Sierrita Operations
Environment, Land & Water Department
6200 West Duval Mine Road
PO Box 527
Green Valley, Arizona 85622-0527

May 23, 2014

**Re: Response to Comments, Voluntary Remediation
Groundwater Investigation Report Freeport-McMoRan
Sierrita Mine Green Valley, Arizona; Site Code: 100073-03**

FIGURE 13
1940 APPROXIMATE STEADY STATE
GROUNDWATER LEVEL CONTOURS

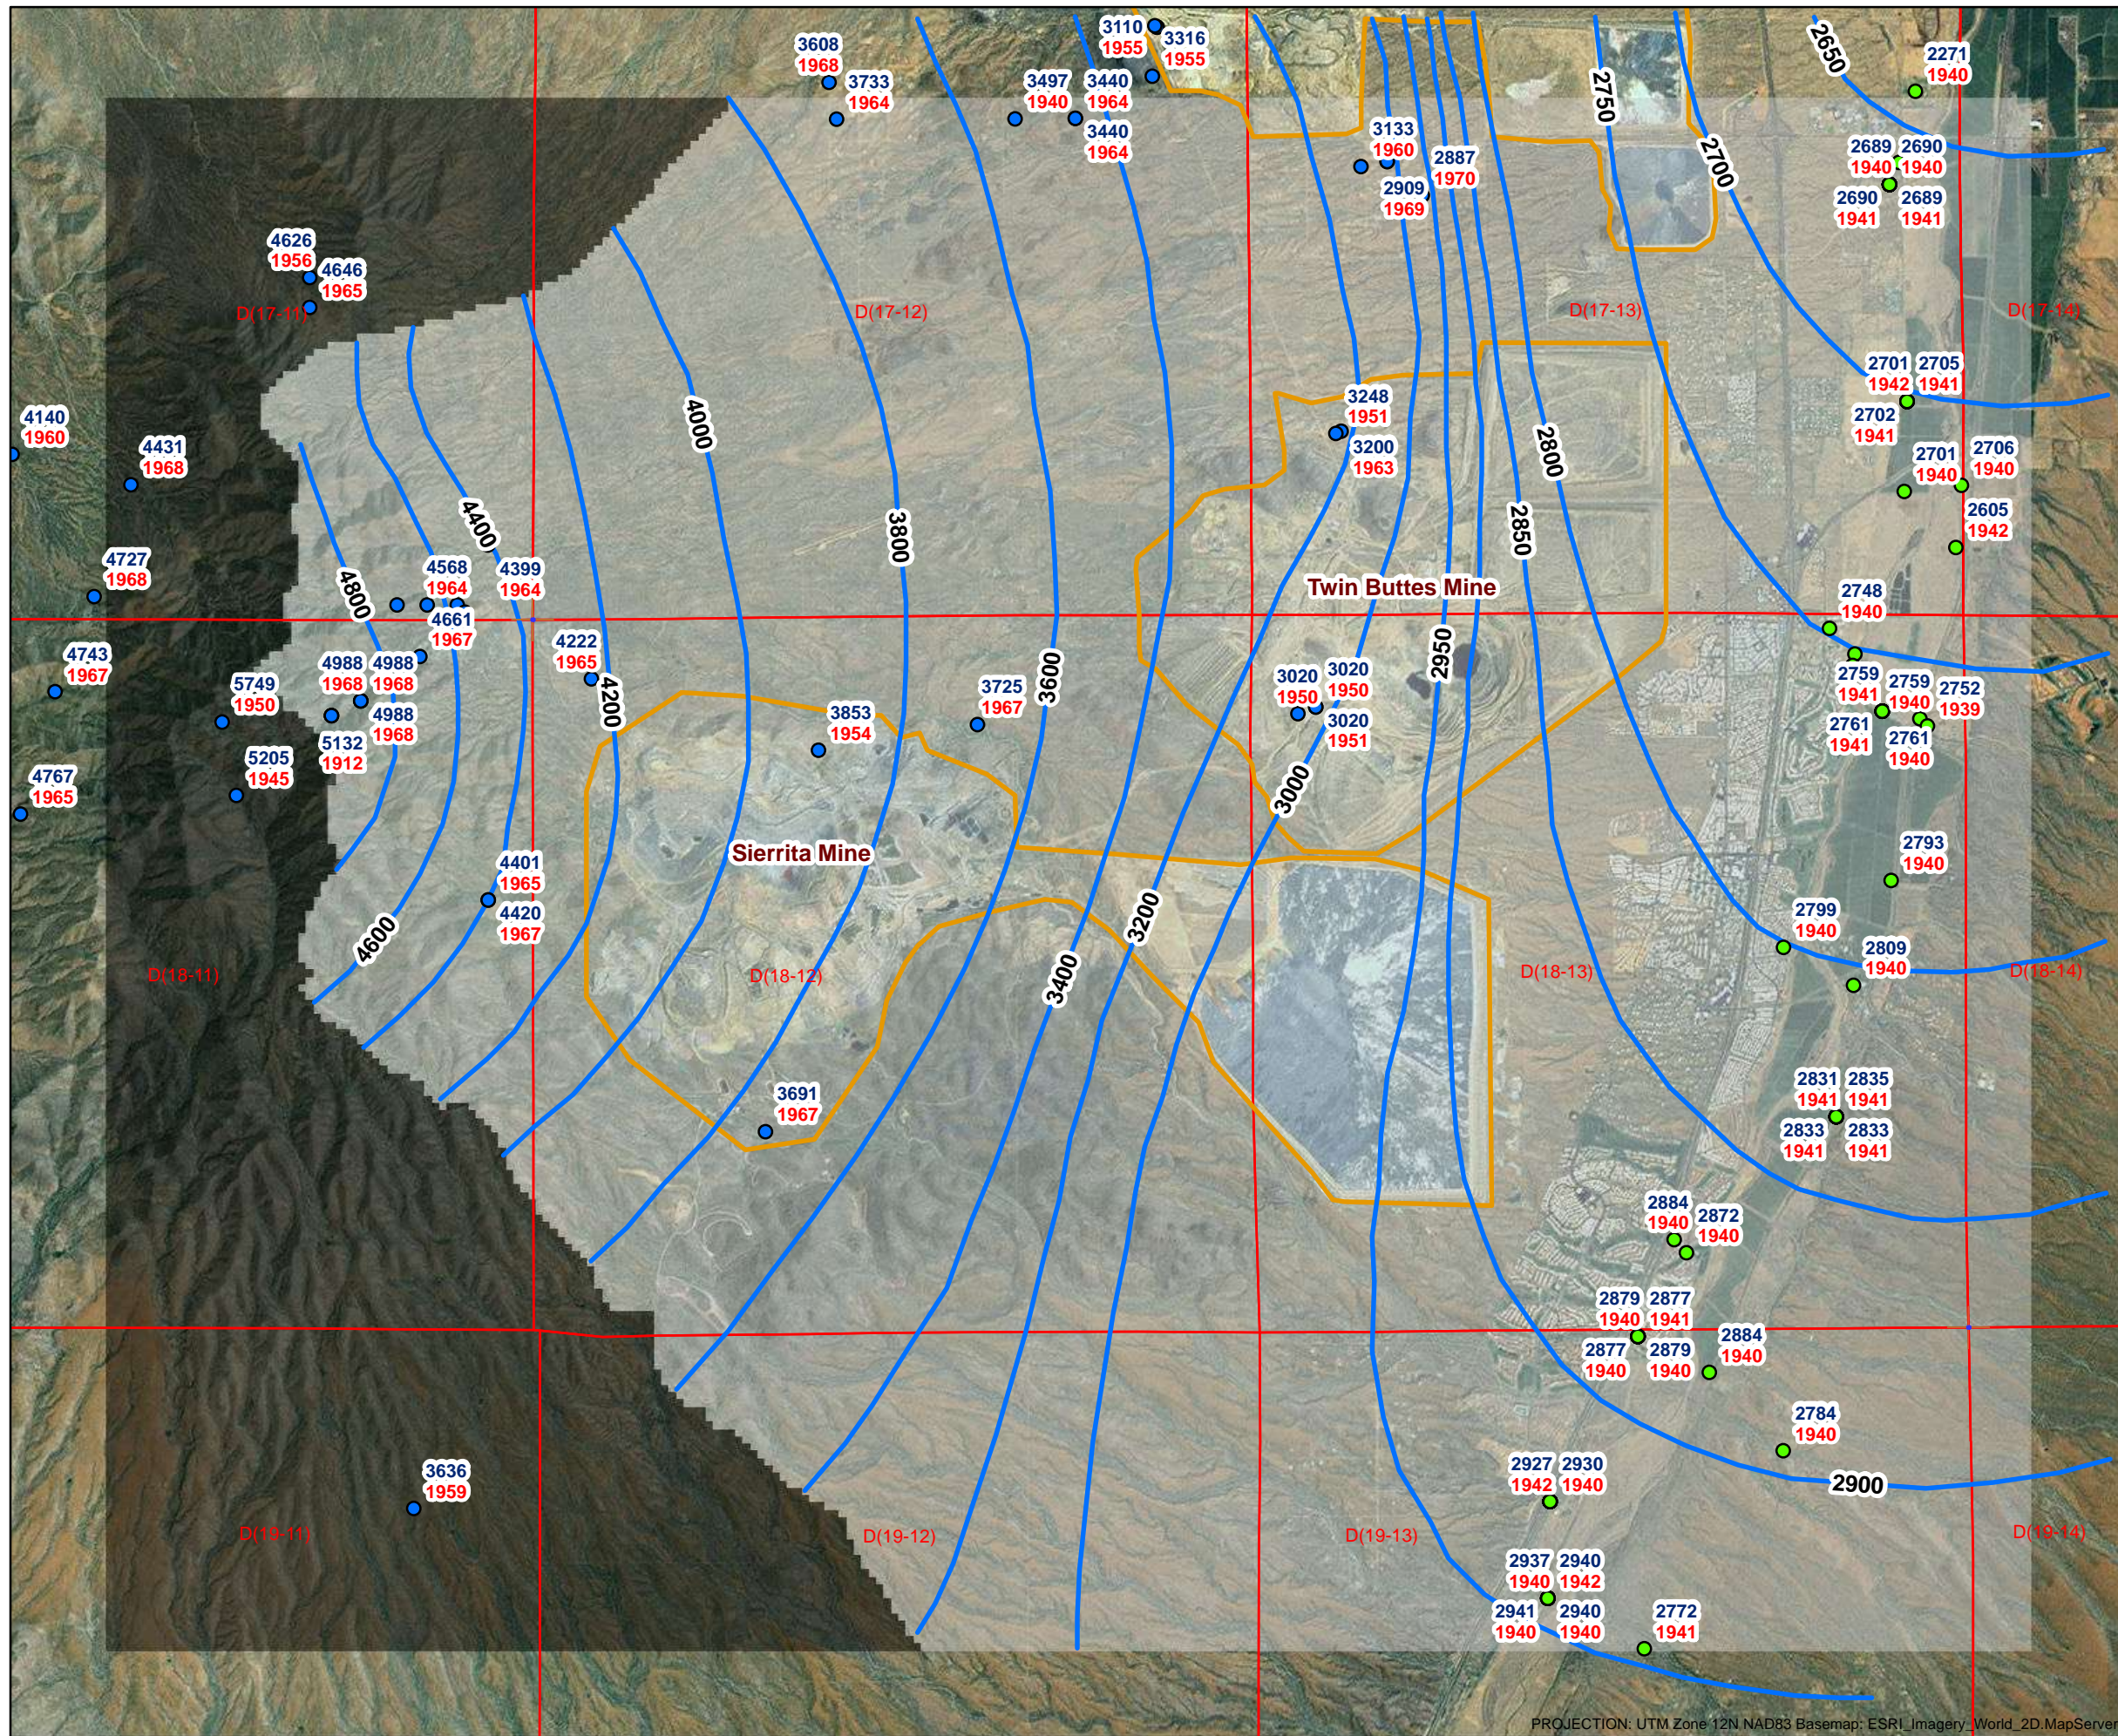
16. **ADEQ Comment:** *Figures 11 through 14: VRP notes that the groundwater contours depicted on the potentiometric maps refer to wells MH-21, MW-2008-12, MW-2008-13, MH-17, MW-2008-14, MW-2008-15, and PZ-01 as "background wells". VRP does not completely agree that these wells are adequate to provide a true representation of background water quality. Only MW-2008-12 is shown to be upgradient of Sierrita mining operations and/or disturbed ground. However, VRP notes that MW-2008-12 could be hydraulically downgradient of the Twin Buttes mine site and therefore may not actually represent true background..*

The hydrology of the Site indicates a southeasterly groundwater flow direction. This is shown by both by the groundwater level data presented in the Report (see Figures 11 through 14 in the Report) and the Sierrita and Twin Buttes Mines Passive Containment Capture Zone Analysis (PCCZ Report), which includes additional monitoring well data both regionally and at the Site. Both hydrogeologic interpretations of well data support the assertion that the wells in the North and West Background Areas are hydrogeologically upgradient of mine activity and disturbances. Additionally, as the PCCZ report indicates, active dewatering of the Sierrita Pit also draws water into the pit itself: as shown, some of the groundwater underneath the West Waste Rock Piles actually flows towards the open pit rather than south-southeast. Figures 13, 14 and 18 from the PCCZ Report are included for reference (see Attachment 3).
